TECHNICAL REVIEW AND ADVISORY PANEL (TRAP) MEETING

TECHNICAL REVIEW AND ADVISORY PANEL (TRAP) MEETING MINUTES

Subject: Nitrogen-Reducing Media Lined Drainfields

COMMENTS FROM VARIANCE COMMITTEE MEMBER - ENG
James Schivinski, P.E.,

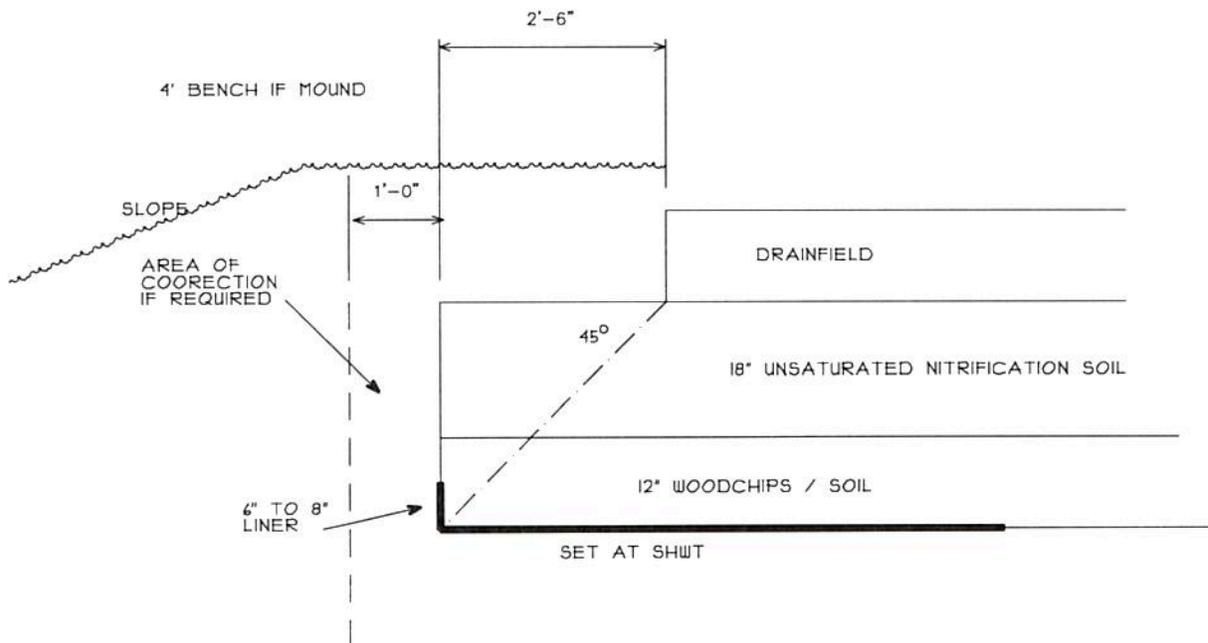
1. Require all systems to be low pressure dosing.
2. A 25 percent reduction giving to drain field size, no reduction to unobstructed area.
3. The bottom of the system set at the SHWT.

Due to the difficulty in determining SHWT in naturally occurring soils vs disturbed or existing systems there might need to be some discussion on where to set the bottoms?

The system must be able to be constructed, the other (3) examples would be very difficult to build.

If the above could be considered, this might be a good option for all systems, only 6' higher than required now and you get the 25% reduction.

Figure 3 – Variant Two

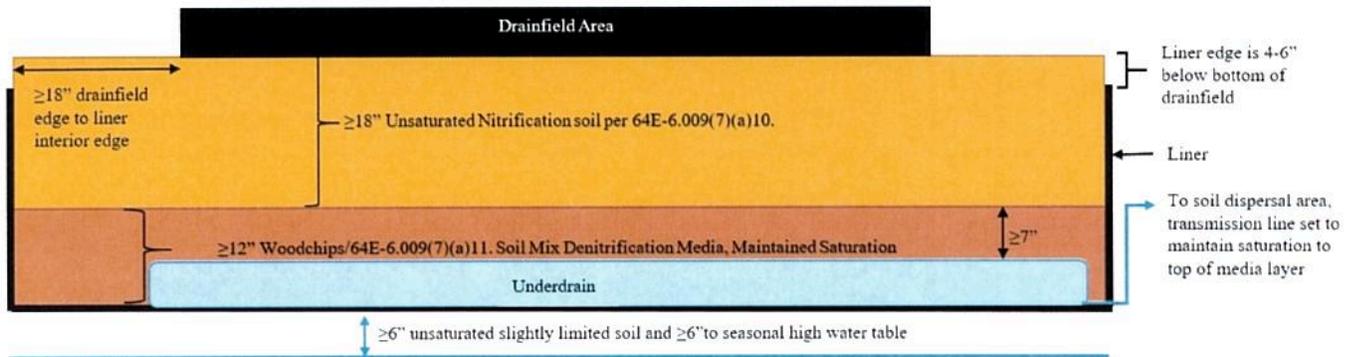
Figure 3 – top of liner should be 4-6 inches below the bottom of the drainfield.

177 Figure 4_ Variant Three

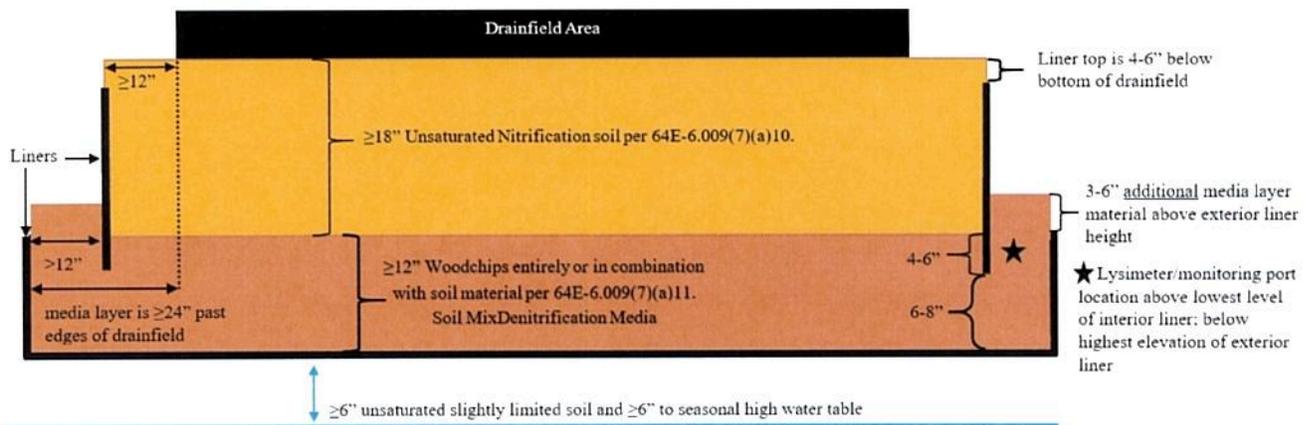
Figure 4 - top of liner should be 4-6 inches below the bottom of the drainfield.

Figure 4 – bottom of inner liner should be 6-8 inches above the bottom of the outer liner.

Perimeter loading factor needs to apply to the outer liner of variant 3.
